PMSTPCOL PEmails

From: Brad Harvey
Sent: Friday, August 22, 2008 3:58 PM
To: Ramsdell, James V Jr (Van)
Cc: Paul Kallan; Raj Anand; Charles Cox; STPCOL
Subject: STP COL FSAR EAB & LPZ X/Q Values
Attachments: RAI Letter_06122008.pdf

South Texas Project
Units 3 and 4
Docket Nos. 52-012 and 52-013
Response to Requests for Additional Information

Figure 1
STP Stability Class Frequency Distributions

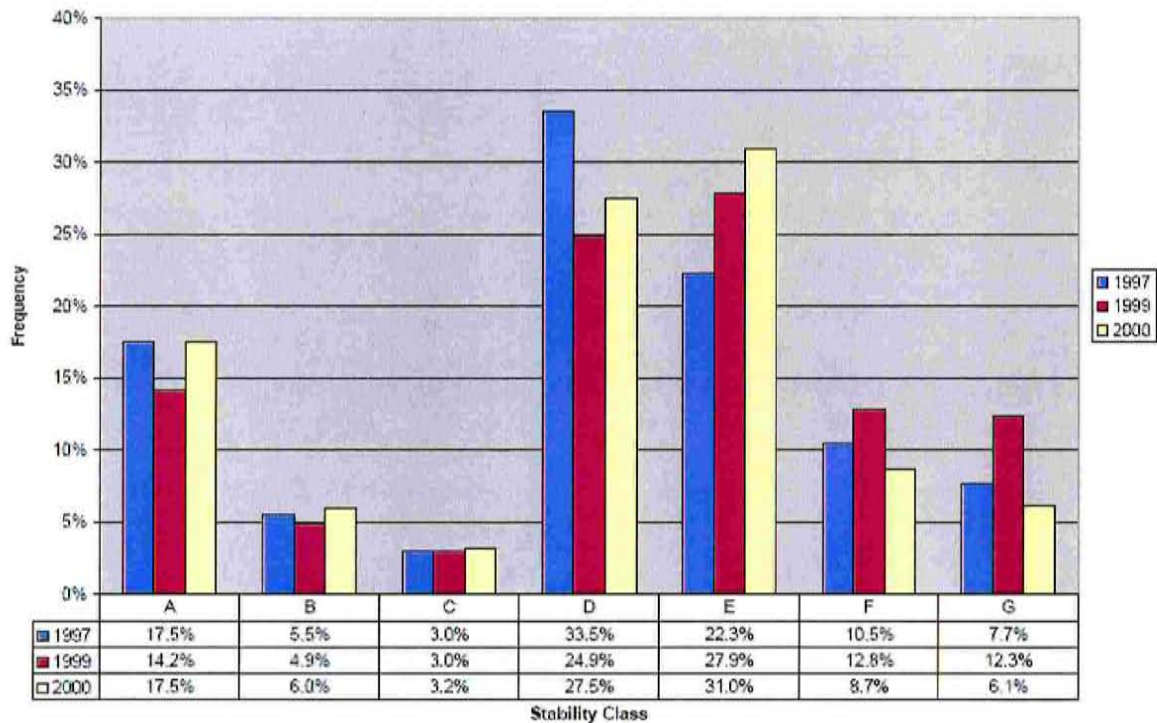
Please explain the variation in onsite G stability class frequency distribution from year to year (e.g., 12.3% in 1999 versus 6.1% in 2000) as shown in Figure 1.

The G stability Class frequency differences are attributed to year-to-year variation and are within the norm of the yearly variation. Examination of seven years of STP onsite historical stability class frequency distribution data show several year-to-year variations of greater than 6.2% (the G stability Class frequency difference between 1999 and 2000), for stabilities other than G.

Distance from Units 3 & 4 to EAB

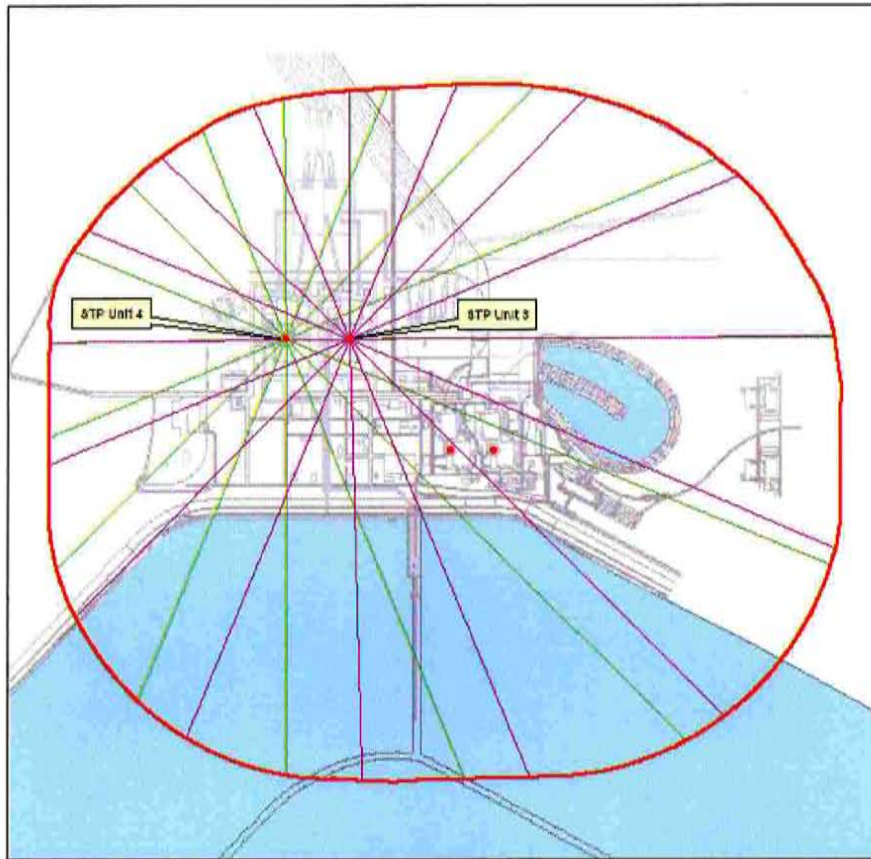
I know we've discussed previously that you've had an issue with the methodology used by STP to calculate their design-basis accident X/Q values for the EAB and LPZ. I have another issue in that I don't think they have appropriately defined the downwind distances to the EAB and LPZ. See their response to RAI 02.03.04-3 on page 6 of the attached letter.

The response to RAI 02.03.04-3 states that the releases to the exclusion area boundary (EAB) and outer boundary of the low population zone (LPZ) were assumed to be located at the center of either Unit 3 or Unit 4 and not the nearest point on the building to the EAB or LPZ as discussed in RG 1.145. The response further states that the shortest distance to the EAB was in the NW direction and the difference in distance from the edge of the reactor building to the EAB is approximately 41 meters shorter than if measured from the center of Unit 4. The applicant believes this 41 meter difference in distance does not significantly affect the χ/Q values predicted at the EAB.

STP 3 & 4 FSAR Figure 2.3S-23 shows the assumed accident release locations used to derive the control room χ/Q values. One of the release locations is the turbine building truck door, which is located at the NW corner of the turbine building. The staff estimates that this release location is approximately 120 meters closer to the EAB in the NW direction as compared to the NW edge of the reactor building. Consequently, the staff is not convinced that the applicant's alternative approach to calculating downwind distances to the EAB and LPZ using the shortest distance from the center of either Unit 3 or Unit 4 as described in its response to RAI 02.03.04-3 is conservative.

Section C.1.2 of Regulatory Guide 1.145 states that for each of the 16 direction sectors, the distances to the EAB and LPZ to be used in the χ/Q calculations should be the minimum distance from the stack or, in the case of releases through vents or building penetrations, the nearest point on the building to the EAB or LPZ within a 45 degree sector centered on the compass direction of interest. Please confirm that this was the approach used in deriving the distances to the EAB and LPZ presented in FSAR Table 2.3S-21 and 2.3S-22, or justify an alternative approach.

As shown on the attached figure, our alternative approach uses the distance from the center of Unit 4 in the NW direction. The shortest distance from the center of Unit 4 to any point in the 45-degree sector is similar. It is acknowledged that in the NW direction, the difference in distance from the edge of the reactor building to the EAB is about 135 feet (41 meters) shorter than if measured from the center of Unit 4. A 4.4% (41 m/930 m) difference in this distance does not significantly affect the χ/Q value predicted at the EAB.

The following discussion provides the basis for this selection. When varied direction-specific boundary distances are entered into the PAVAN code, the model cannot generate the overall 5% χ/Q values. This is a limitation of the PAVAN code. In order to obtain the maximum overall 5% χ/Q value, PAVAN was run separately for each direction-specific boundary distance for each of the 16 different directions. The ultimate maximum 0-2 hour χ/Q value was selected from the 16 sets of data using the lowest or most conservative distance (930 m). As reported in FSAR Tables 2.3S-23 and 2.3S-24, the maximum overall 0-2 hour 5% χ/Q at the EAB and LPZ, respectively, was selected by the above alternative approach.

Specifically, the 0-2 hour maximum overall 5% χ/Q at the EAB (1.96E-04) was obtained from a PAVAN run using a constant downwind distance of 930 meters for all directions. In reality, aside from only this one sector (NW direction), the downwind distances to the EAB are all greater for the rest of the directions. This approach is conservative because it assumes all downwind distances are 930 meters to the EAB.

In conclusion, the net result of the conservative approach used in the final selection of the 0-2 hour maximum χ/Q values out-weighs the use of the distance measured from the center of Unit 4, rather than from the nearest point on the building.

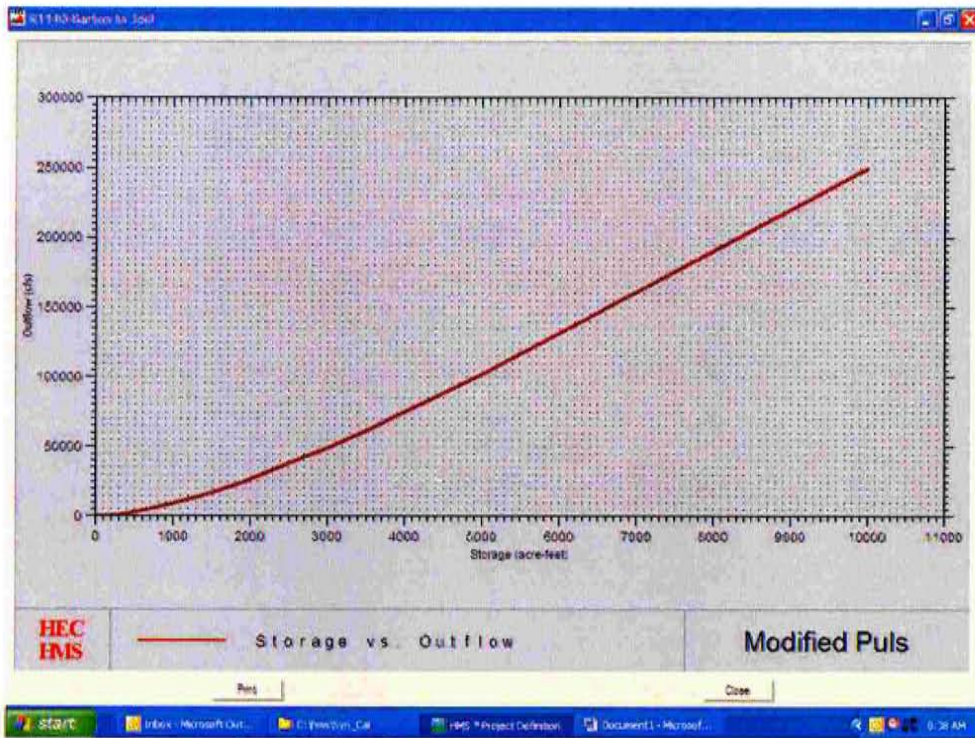
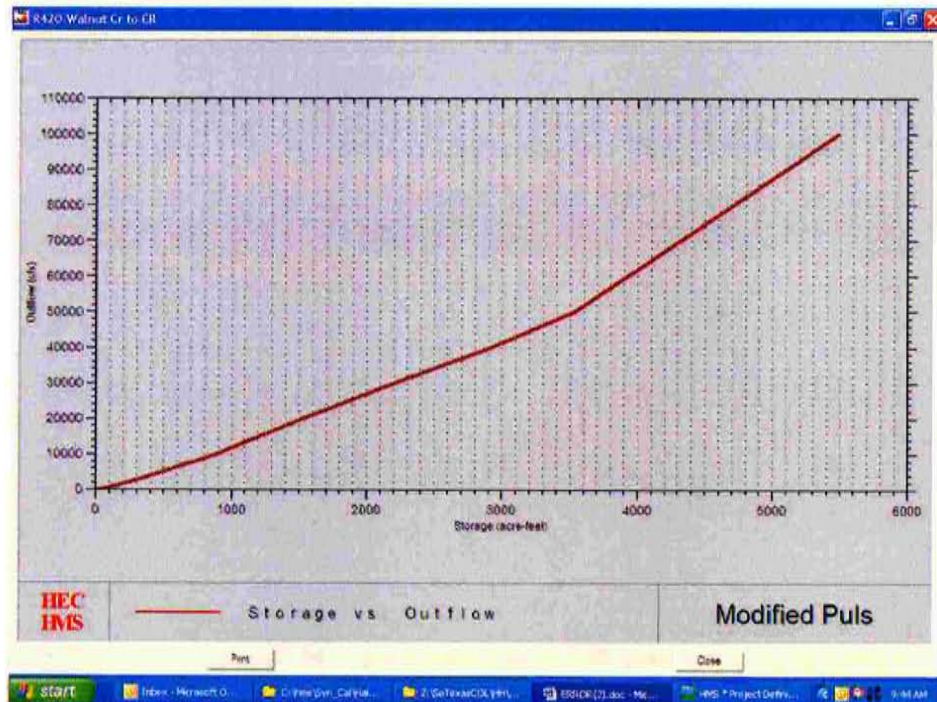
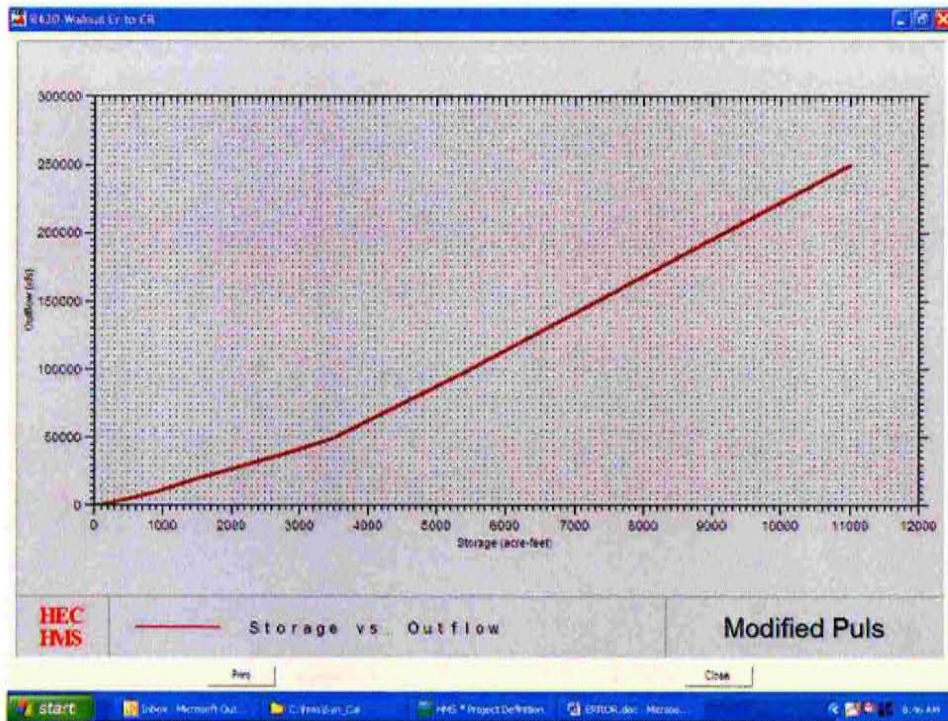
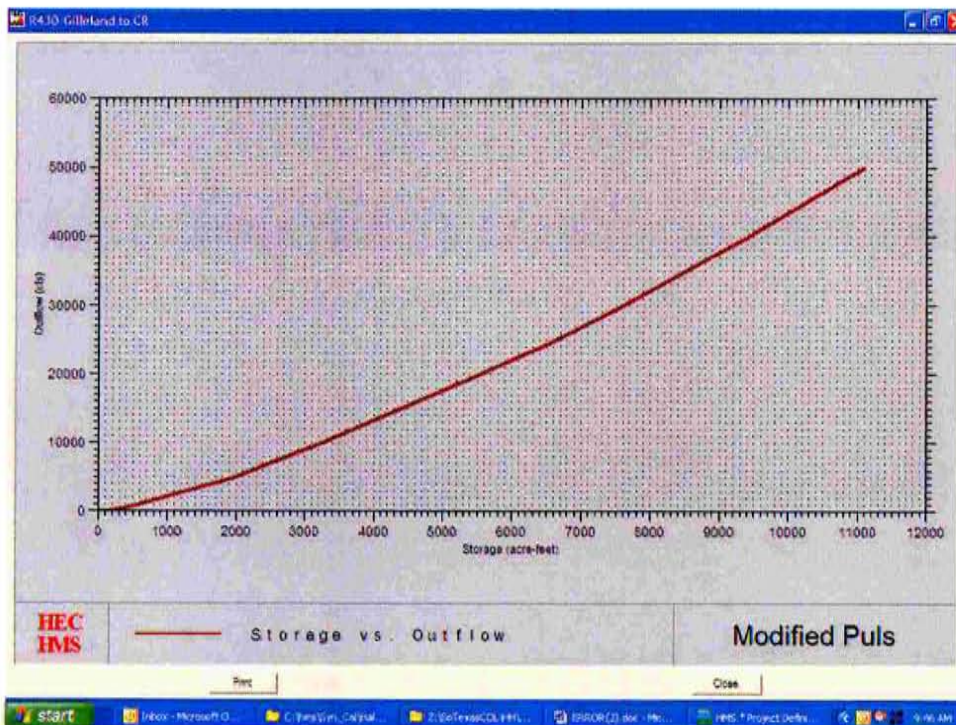
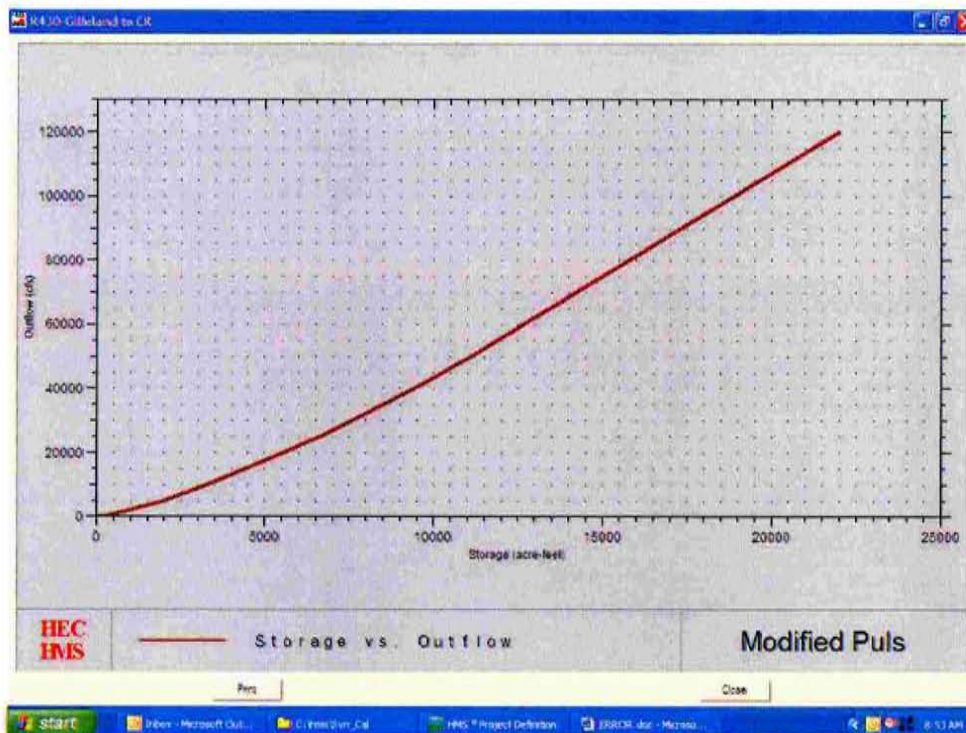
Provide details of the linear extrapolation used to extend the channel rating curves between Mansfield Dam and Matagorda Bay described in FSAR Section 2.4S.3.3.

A linear extrapolation was used to extend three channel rating curves: R1140-Barton, R420-Walnut Cr, and R430-Gilleland. The following figures provide the original rating curves used in the Half HEC-HMS Model and the extrapolated rating curves used for the Probable Maximum Flood (PMF) Analysis in FSAR Section 2.4S.3.

FIGURE 9.3-11 PIPING AND INSTRUMENTATION DIAGRAM, RADIOACTIVE DRAIN TRANSFER (SHEET 1 OF 22)

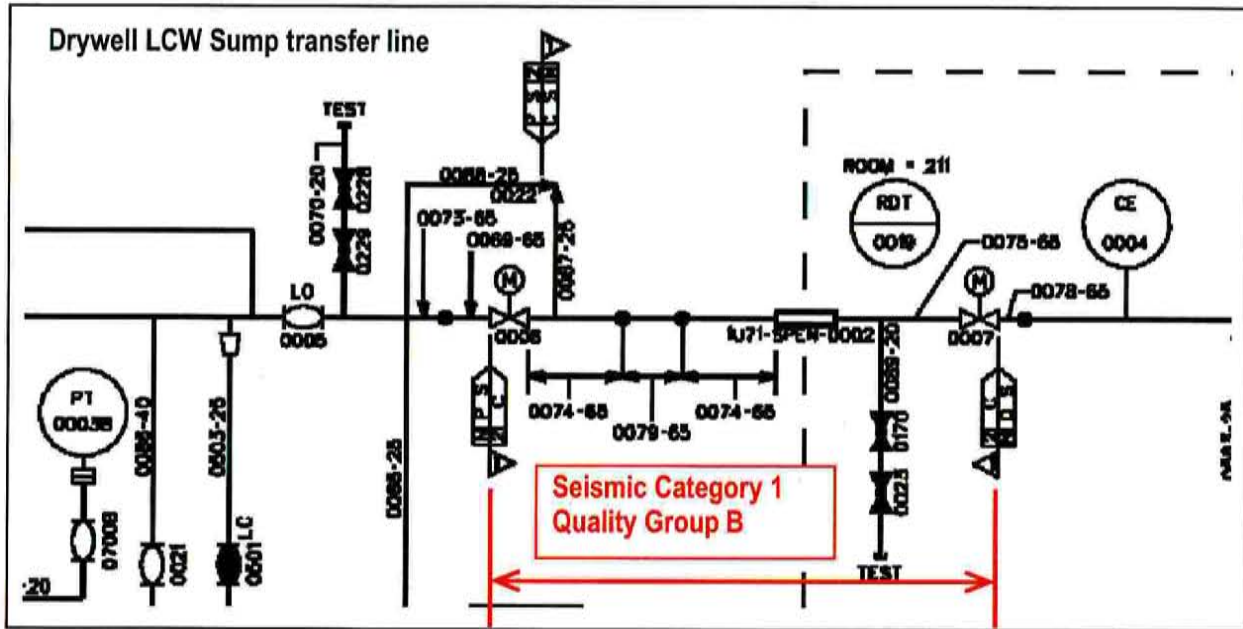
Please clarify if MOV 006 and MOV 007 in Sheet 1 of COLA FSAR Revision 1, Figure 9.3 11, are containment isolation valves.

The valves numbered as MOV 0006 and MOV 0007 in Sheet 1 of Figure 9.3.11 are containment isolation valves. Sheet 5 of Figure 9.3.11 in the current FSAR revision incorrectly shows the containment isolation valves, which are numbered 0057 and 0065, as ball valves. Sheet 5 will be corrected to show both as motor operated isolation valves as attached.

FIGURE 9.3-11 PIPING AND INSTRUMENTATION DIAGRAM, RADIOACTIVE DRAIN TRANSFER (SHEET 5 OF 22)

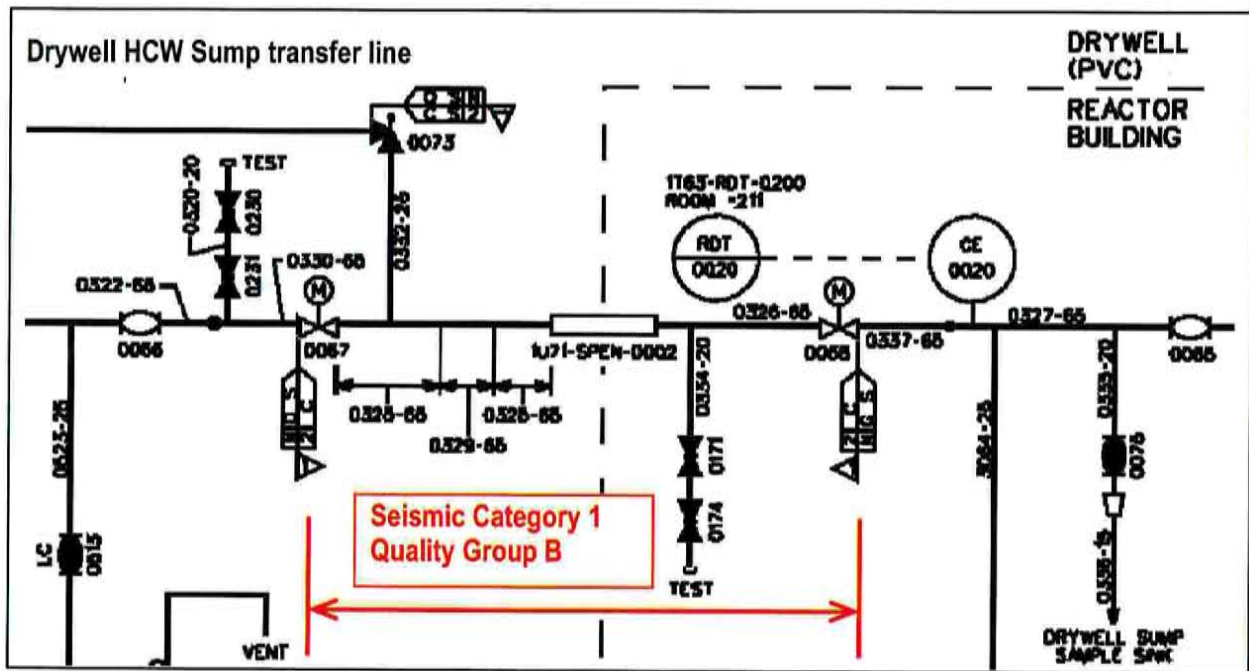
- The staff was unable to verify the designations of the Seismic Category 1 and Quality Group B portions of the system described above due to low quality of drawing.
- The staff noted that there are inconsistencies between COLA FSAR Figure 9.3-11 and ABWR DCD Tier 2 Figure 1.7-1. For example, the piping identification format does not follow the convention described in Note 10 of Figure 1.7-1.
- In Sheets 13, 15, and 17 of Figure 9.3-11 the symbols for some check valves are inconsistent with Note 6 of Figure 1.7-1.

The COLA will be revised to provide P&IDs with higher resolution and symbols that are legible and consistent with ABWR DCD Figure 1.7-1. For your review, the designations of the Seismic Category 1 and Quality Group B portions of the Radioactive Drain Transfer System are shown on the next page of this Attachment.

FIGURE 9.3-11 PIPING AND INSTRUMENTATION DIAGRAM, RADIOACTIVE DRAIN TRANSFER (SHEET 6 OF 22)

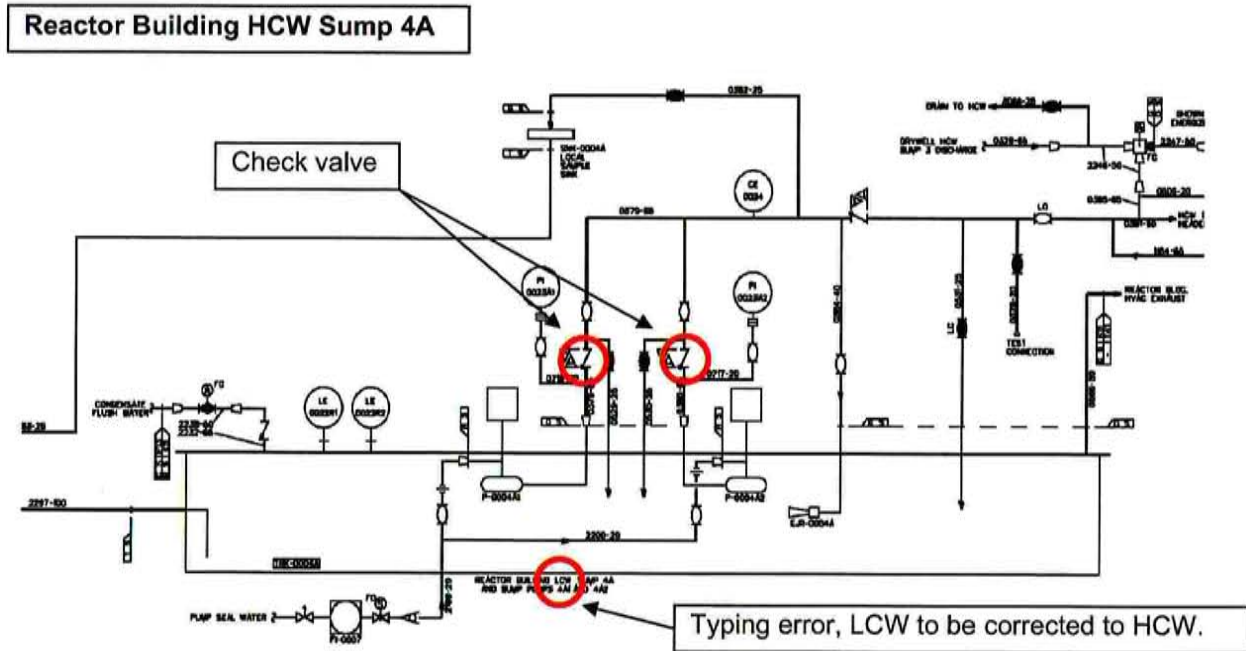
ABWR DCD Section 9.3.8.1.1, "Safety Design Bases" Item 5(a) states that backflow check valves should be included in the ECCS equipment room sumps. Item 5(b) states that floor drain piping in each divisional area of the ECCS pump rooms and the Control Building shall be arranged so that flooding or backflow in one quadrant will not adversely affect other quadrants. The staff could not locate in the P&IDs the check valves and sumps for each ECCS equipment room. Please include these components (or add a reference to) in COLA FSAR Figure 9.3-11.

The drains from the ECCS equipment rooms A, B and C are collected in the individual HCW sumps located in each room. The sumps are HCW Sump 4A on Sheet 6 of Figure 9.3-11, and 4B and 4C on Sheet 7 of Figure 9.3-11. The sump pump is actuated on a water level high signal to prevent flooding. The suction line of each of the relevant sump pumps has a check valve to prevent backflow. The check valve is located in the HCW sump in the individual ECCS equipment room.

Please note that the name of the sump in Sheet 6 is Reactor Building "HCW" SUMP 4A not "LCW" SUMP.
